Planning Commission Staff Report

Meeting Date: February 14, 2022

Description: **P.Z. 12-2021 Estates at Fire Rock (McBride Berra Land Co., LLC):** A request for a change in zoning from an E-1AC Estate District to a PUD—Planned Unit Development for 35.0 acres located at 17803, 17815 and 17831 Wild Horse Creek Road (18V130099, 18V140065, & 18V140098).

Estates at Fire Rock
 17803 & 17815 WILD HORSE CREEK RD., WILDWOOD, MO
 SITE GRADING PLAN

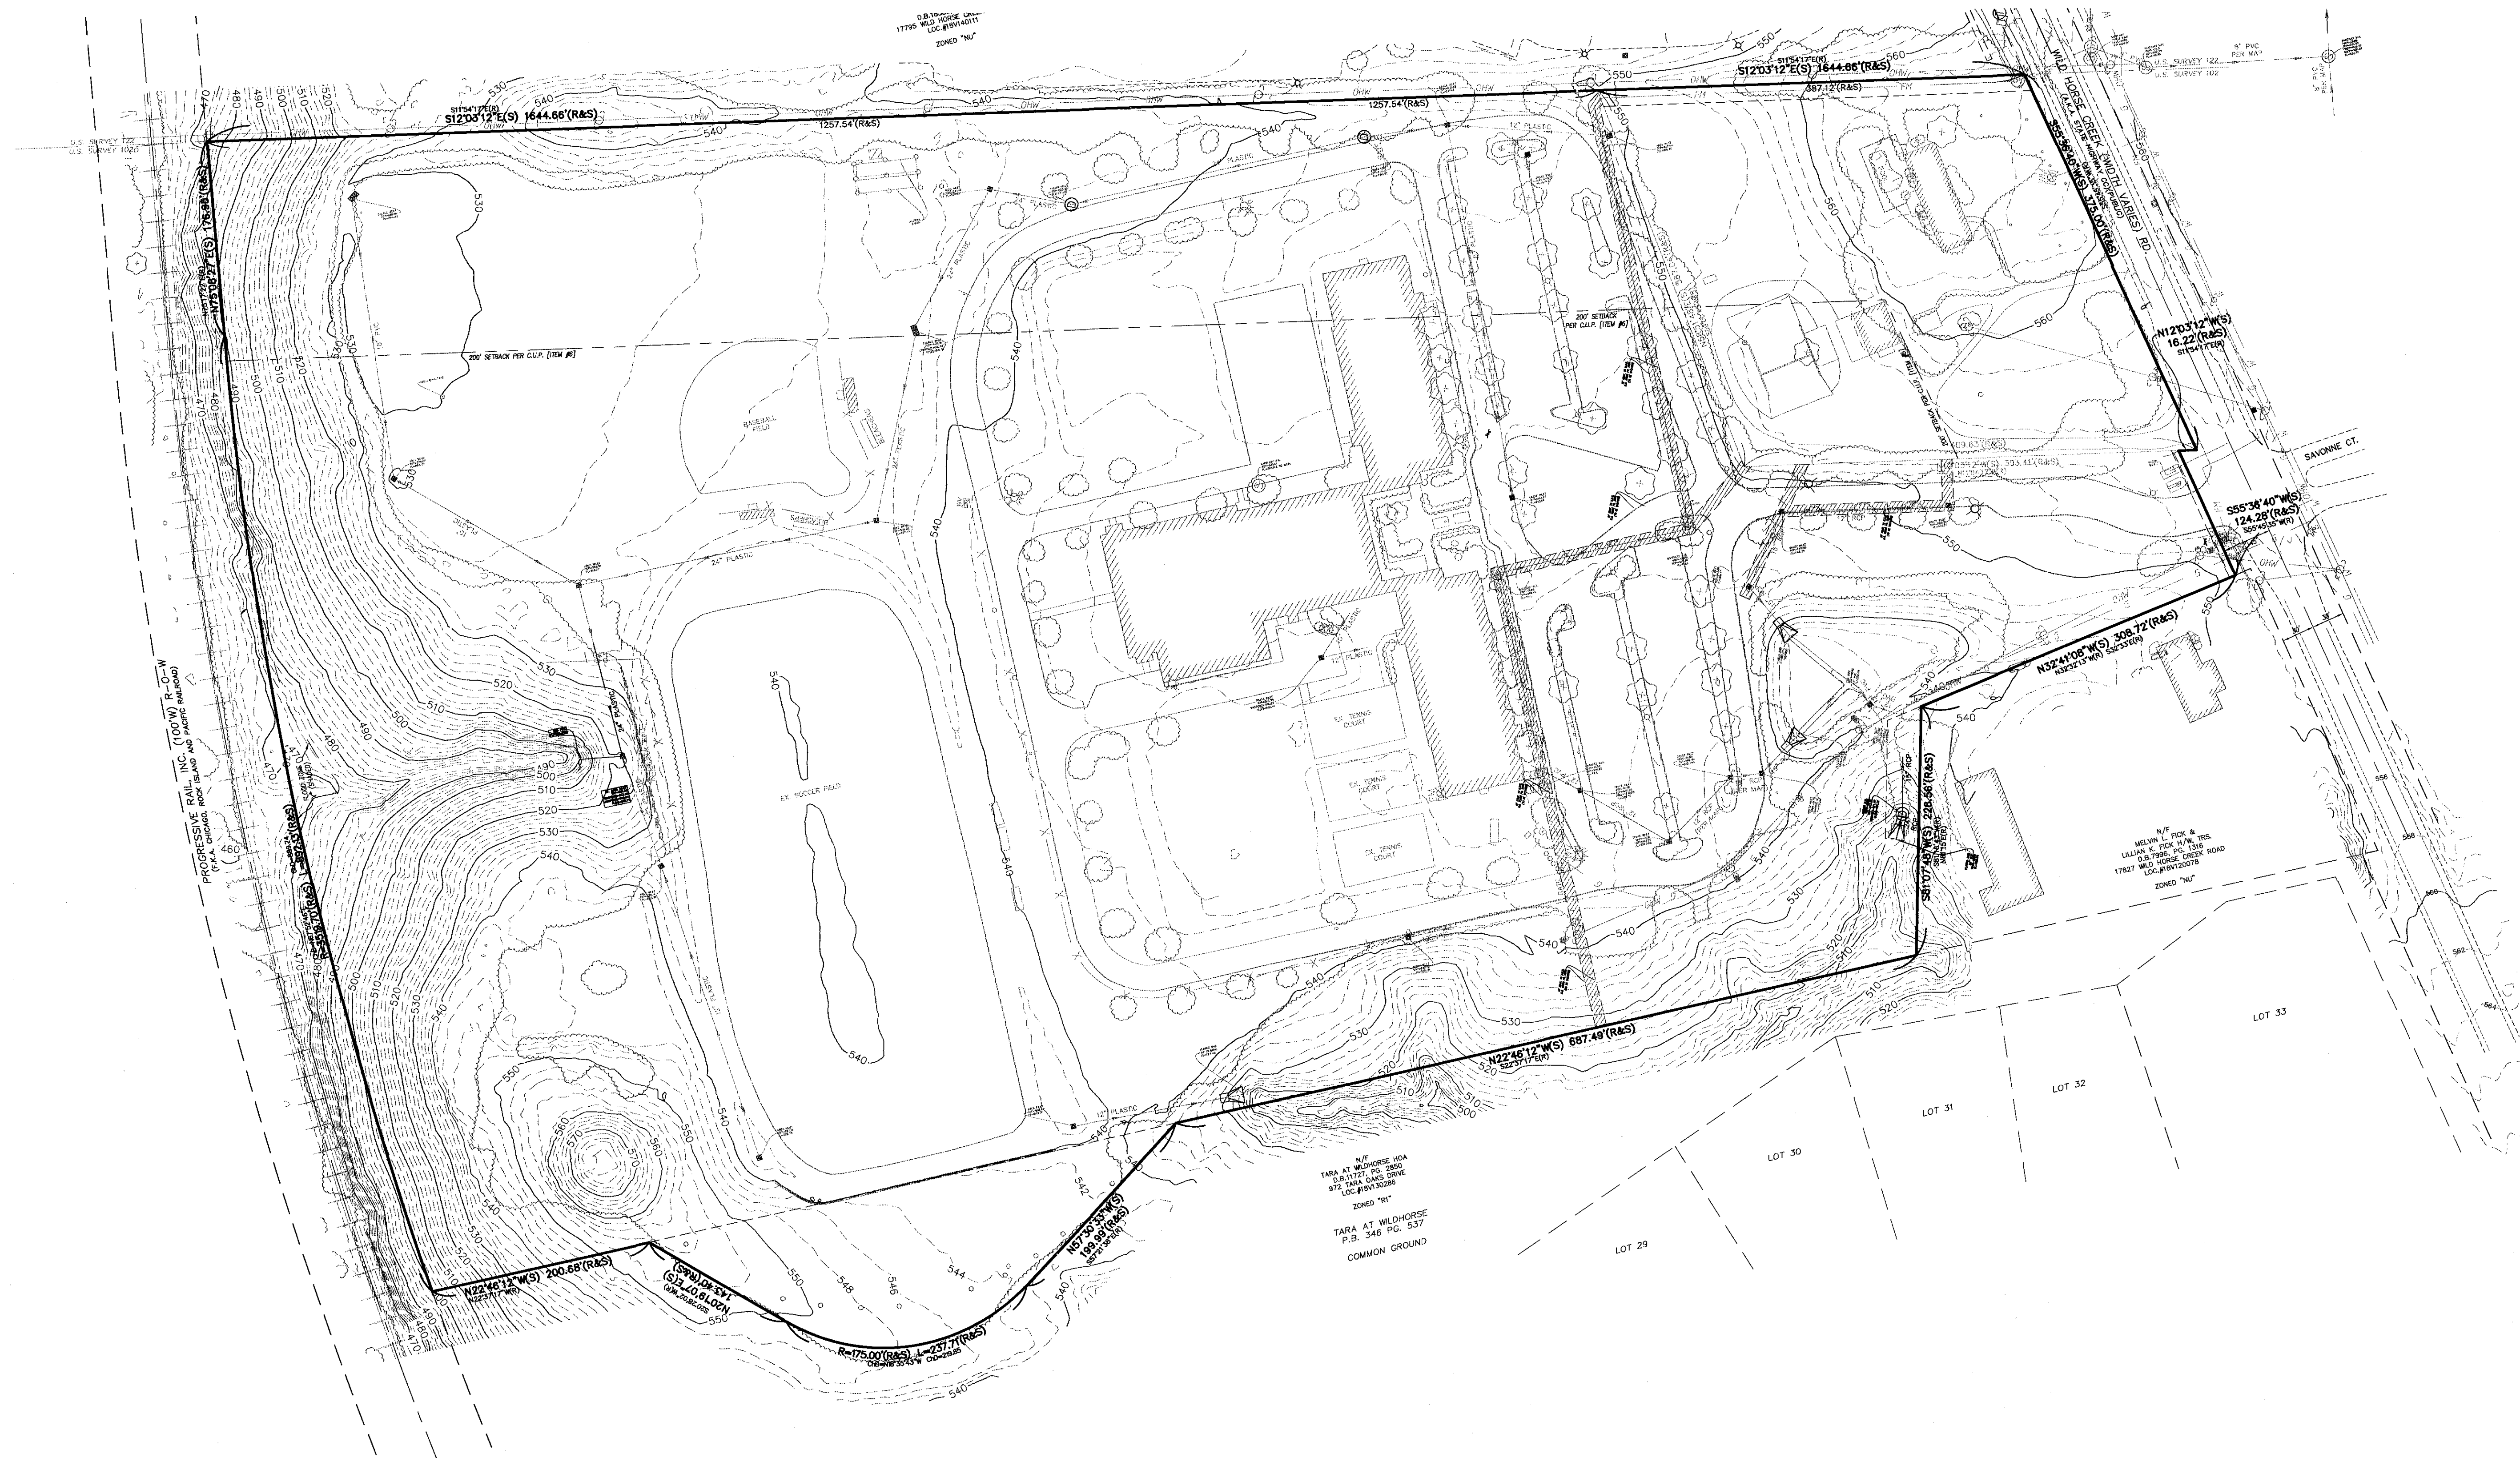
Issue: Access along Wild Horse Creek Rd.—Concern was raised about access to both the proposed subdivision and the adjacent property to the west. Specifically:

- a. Provide cross-access to this adjacent property, adhering to the City's Driveway Access Location and Design Standards.

- b. Provide comments from MODOT regarding how vehicular access and turning movement from and to Wild Horse Creek Rd. will be handled.

- c. Provide the exact distance from the nearest lot to the mound, as shown on the Preliminary Development Plan.

Applicant's response: Cross-access has been provided for the adjacent property to the west on the revised Preliminary Development Plan and complies with the City's Driveway Access Location and Design Standards.

Applicant's response: The applicant has furnished a response from MODOT confirming the agency's approval and conditions for vehicular access from Wild Horse Creek Rd. Such issues will be reviewed during the Site Plan review process following the approval of this request.

Applicant's response: The mound is approximately 160 feet from Lot 25 and 170 feet from Lot 26 on the Preliminary Development Plan.

- 1.a. Cross-access has been provided and shown on the revised plan.
- 1.b. MODOT comments have been provided to you previously. These comments are also addressed on the revised plan.

Job Number
20-07-232
Date
Jan. 27, 2022
Designed: MF Sheet
Drawn: EA **8.1**
Checked: PRE

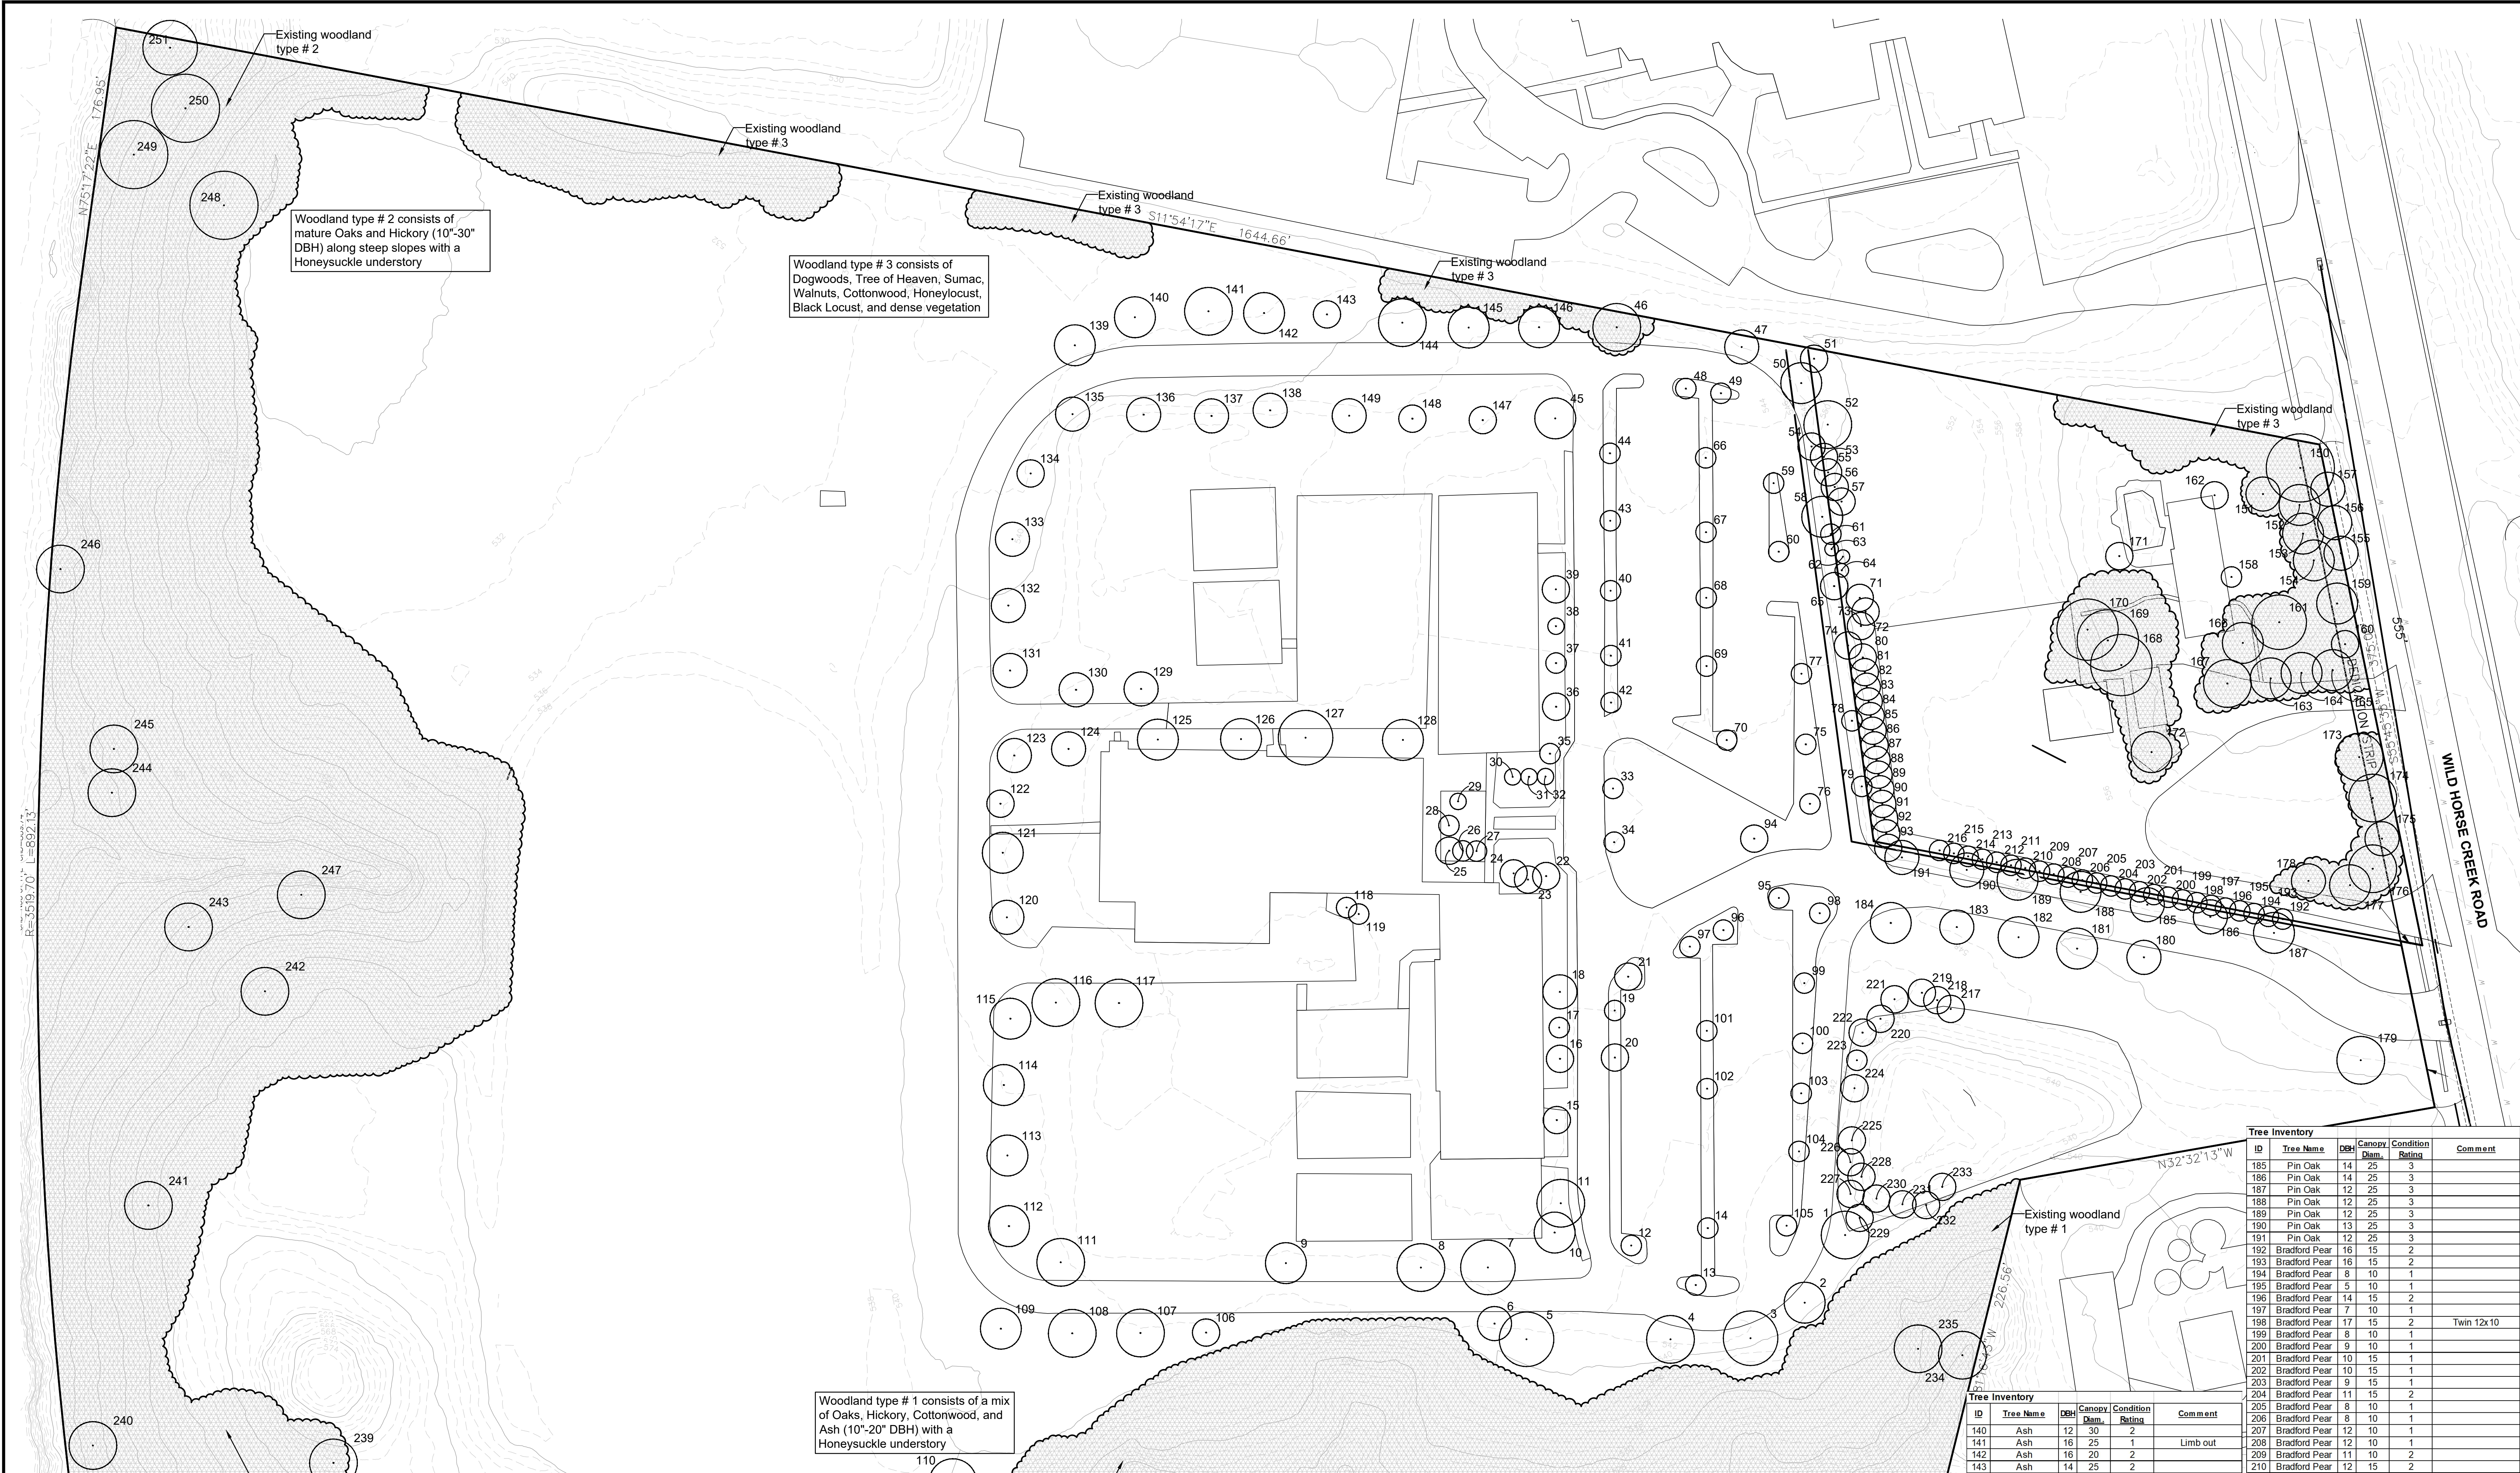
Access Management:
Understood. Sight Distance Analysis has been provided with the plan.
